RE: Sharon W.S.C.
Application to Amend Water CCN (10476)
PWS ID# 2500020
Upshur County, Texas.
Docket #44816 – Order No. 7

We received Order No. 7 March 10, 2016 that there were some insufficient details that needed to be corrected on the mapping requirements. Attached are one original and seven copies for work order No. 7. (As well as 7 CD's) Below are the comments addressed:

SHARON W.S.C.
CCN AMENDMENT APPLICATION
WOOD COUNTY, TEXAS

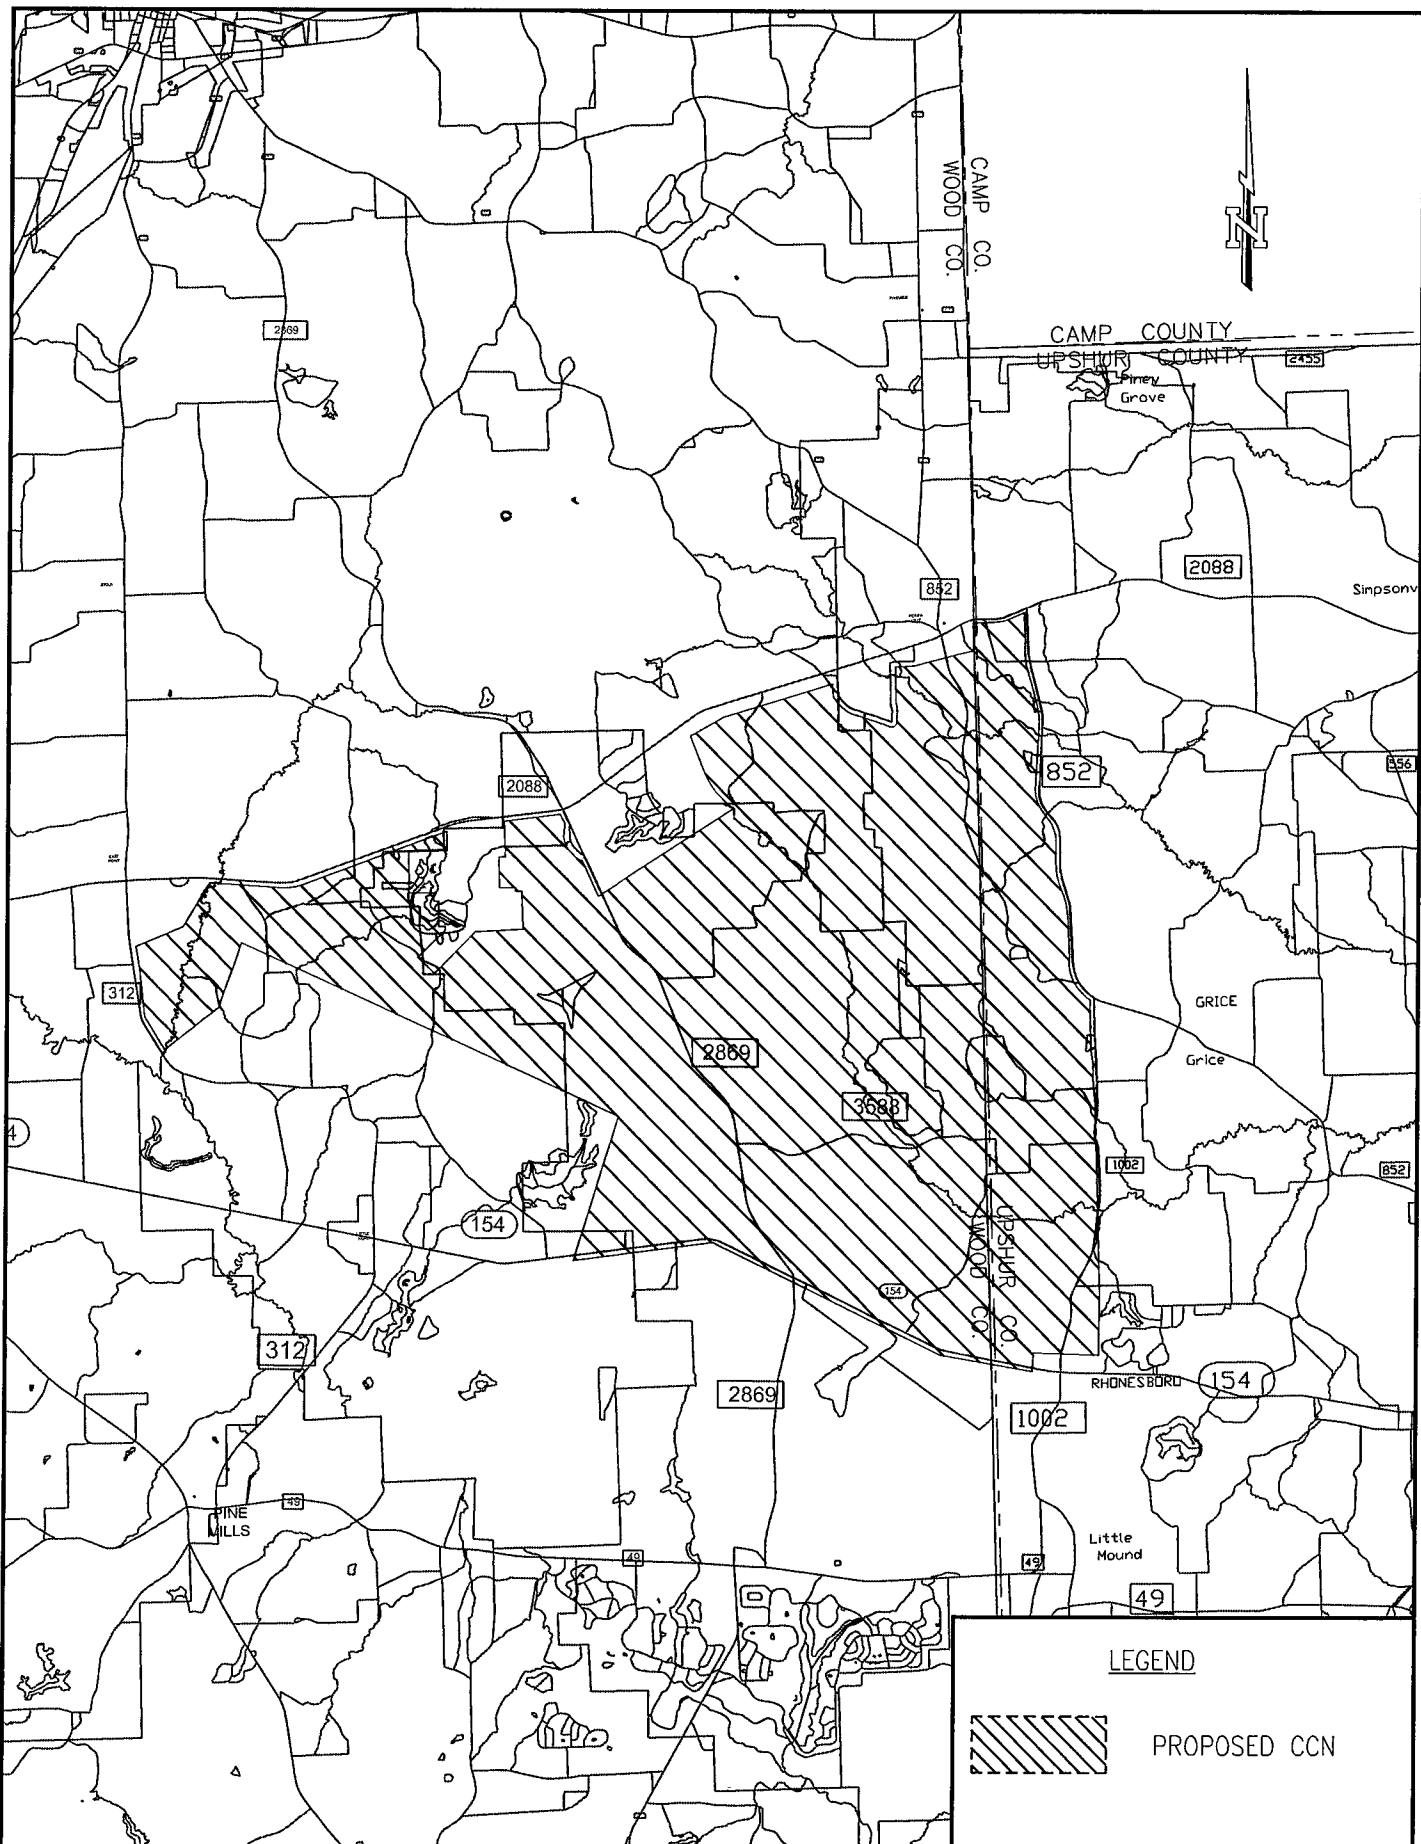
- 1.) A revised small scale (general location) map only showing the proposed water service area with enough detail to locate the service area in the vicinity of the nearest town, city, or county.

- a. **A small scale map showing a general location of the proposed service area is attached.**
- 2.) A large scale (detail) map only showing the proposed water service area with enough detail to accurately locate the service area in the vicinity of surrounding roads, streets, and highways.
